Correction of OSC2 to OSC3 signal flow

From serial 50100 to 50150 there is the following mistake in the Neptune II. Signal source for OSC3 in switch position "VCO 2" can only be the saw wave of OSC2 but it should be selectable of pulse, saw or external input.

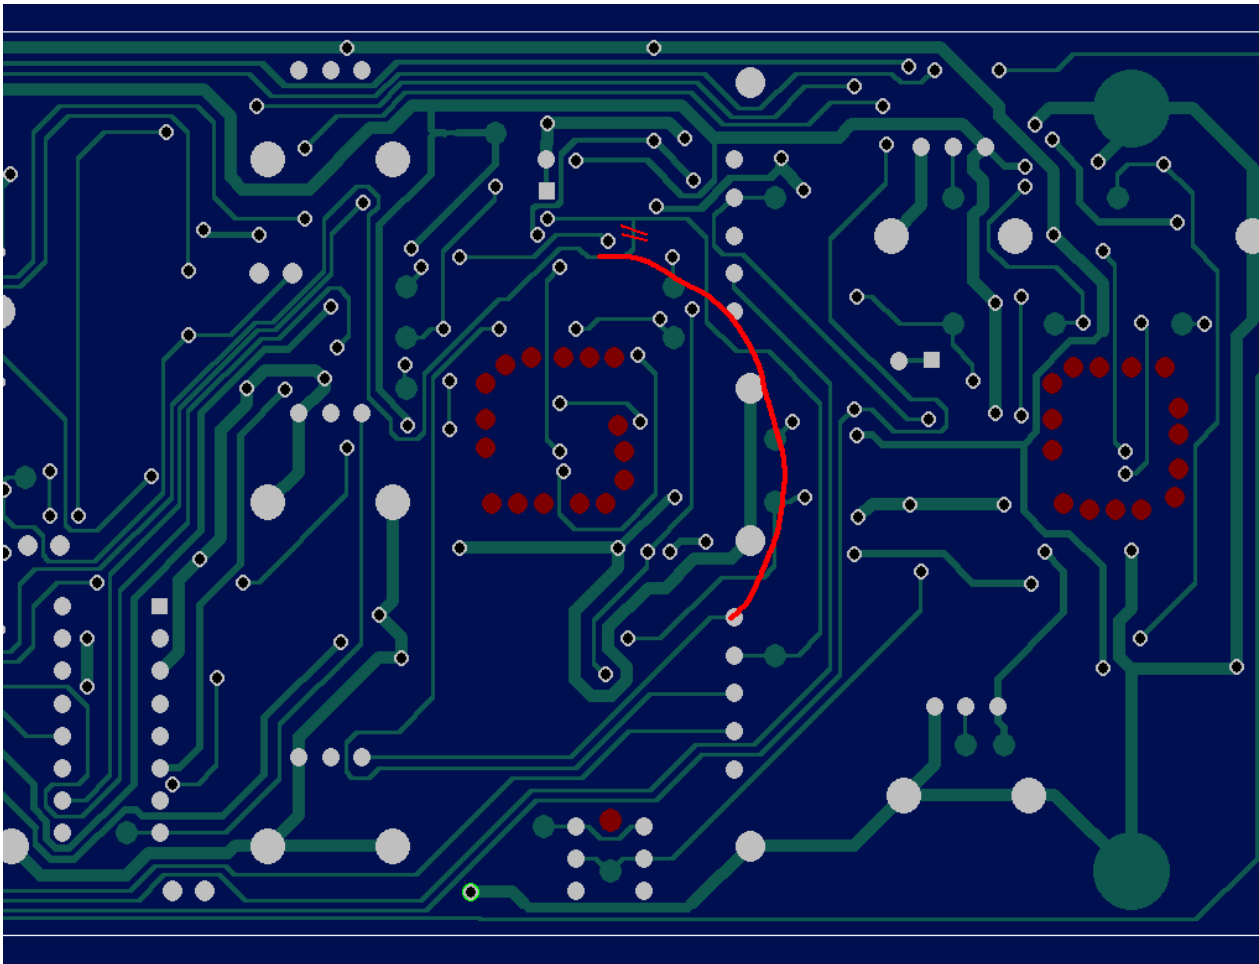
It is needed to cut the track in the picture below on the backside of the pcb and to scratch soldermaskfree a short part of the remaining track and to add a wire like shown in this picture:

After this, it could look like this (note this pcb is not assebled):
